Access Compliance Report

Public Rights-of-Way

Intersection ID: 14867	Main Street: CIRCLE_AV	Cross Street: WILLOUGHBY_ST	Location: SE
ADA ID: 1CAB88E2EF17	Ramp Type: Directional1	Initial Pass/Fail: Fail	Overall Compliance: No
		Severity Score: 25

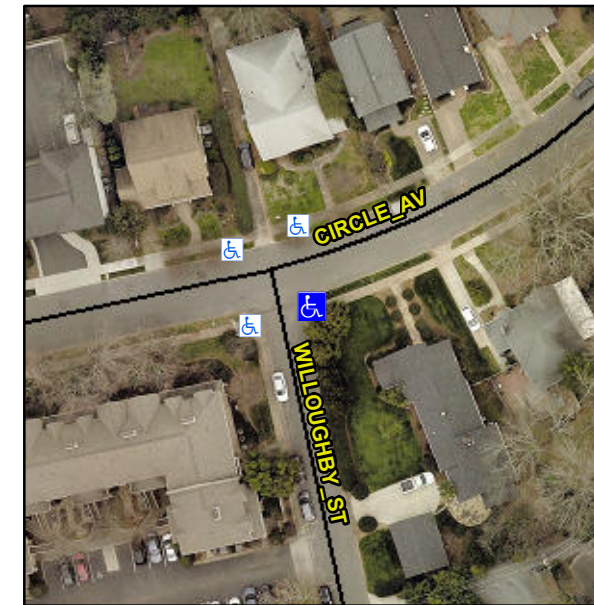
ASP LIP 1.5", CURB LIP 1.0"

R304.5.3

Remove & Replace Entire Ramp.
